SUBJECT: Forwards addl info requested 830407 re containment pressure monitor, containment water level monitor & containment hydrogen monitors installed per requirements of TMI Items II.F.1.4, II.F.1.5 & II.F.1.6.

Subject: NUREG 0737, Items II.F.1.4, II.F.1.5, II.F.1.6
R. E. Ginna Nuclear Power Plant
Docket No. 50-244

REQUEST FOR ADDITIONAL INFORMATION ON NUREG-0737 ITEMS

- II.F.1.4 CONTAINMENT PRESSURE MONITOR
- II.F.1.5 CONTAINMENT WATER LEVEL MONITOR
- II.F.1.6 CONTAINMENT HYDROGEN MONITOR

FIGURE 2

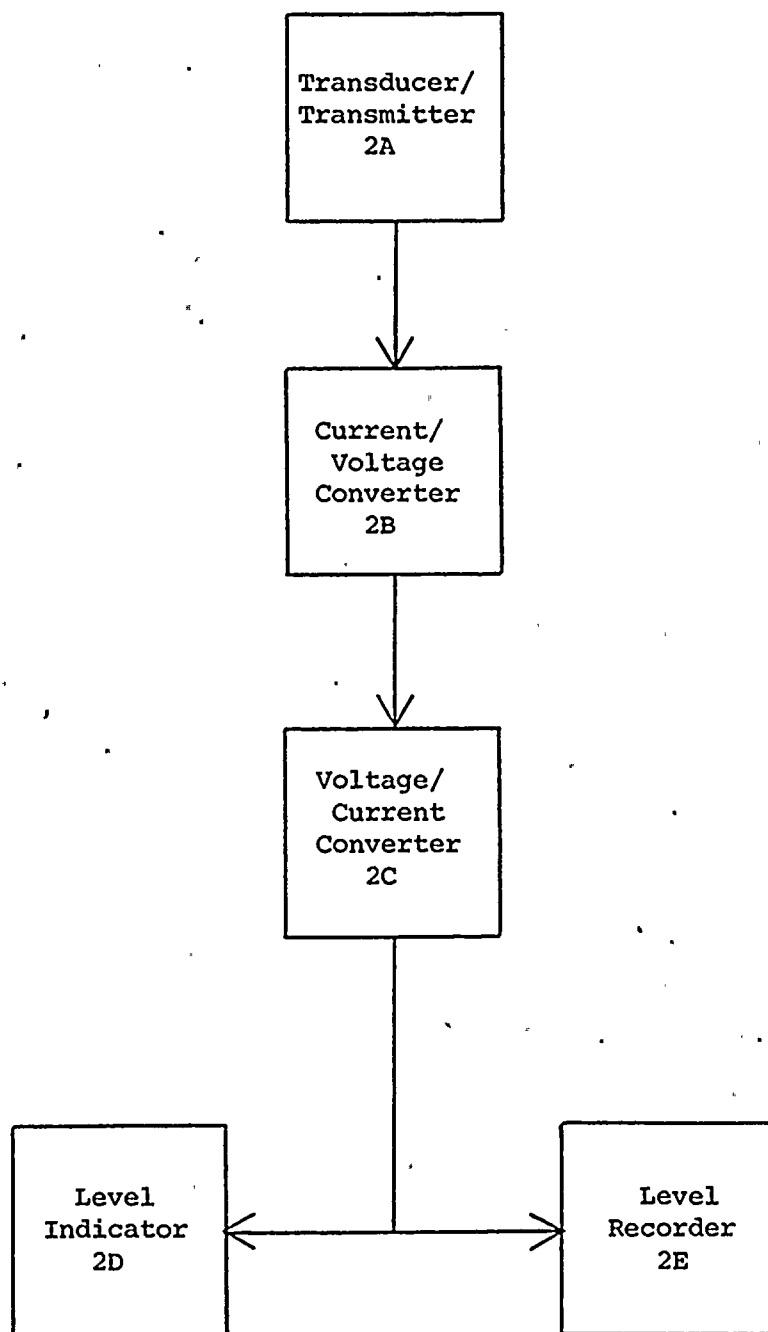
(3a) Provide a block diagram of the configuration of modules that make up your WLMS. Provide an explanation of any details in the block diagram that might be necessary for an understanding of your WLMS accuracy.

(3c) Combine** parameters in 3b to get an overall system uncertainty. If you have both strip chart recorder and indicator output, give the overall system uncertainty for both systems. If you have systems spanning different ranges, give the overall system uncertainty for each system.

Response: See Figures 2 and 3 for block diagrams.

Narrow Range Containment Water Level (Ref. Fig. 2)

2A - $\pm 0.24\%$ of span
2B - $\pm 0.25\%$ of span
2C - $\pm 0.5\%$ of span
2D - $\pm 1.5\%$ of span
2E - $\pm 0.5\%$ of span

Indicator Uncertainty = $0.24 + 0.25 + 0.5 + 1.5 = 2.49\%$ of span

Recorder Uncertainty = $0.24 + 0.25 + 0.5 = 1.49\%$ of span

FIGURE 4

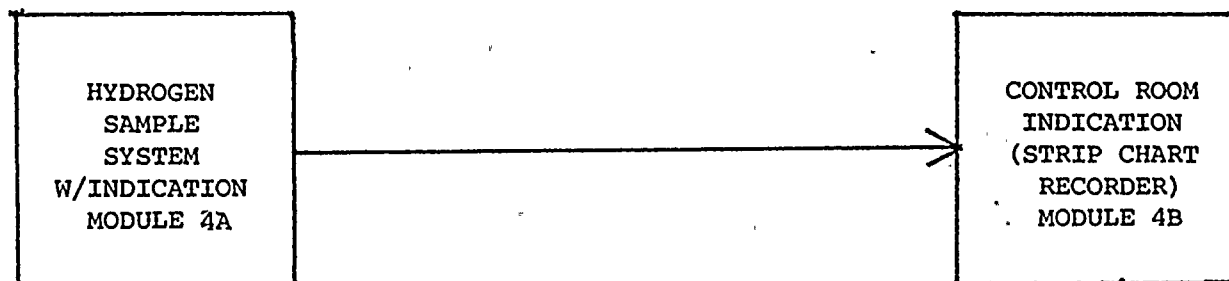
- (4a) Provide a block diagram of the configuration of modules that make up your HMS. Provide an explanation of any details in the block diagram that might be necessary for an understanding of your HMS accuracy. If you have different types of HMSs give this information for each type.

- (4c) Combine** the parameters in 4b to get an overall system uncertainty. If you have both strip chart recorder and indicator output, give the overall system uncertainty for both systems.

Response: See Figure 4 for block diagram.

4A - $\pm 10\%$ of span

4B - $\pm .25\%$ of span

$$\pm 10\% + \pm .25\% = \pm 10.25\%$$
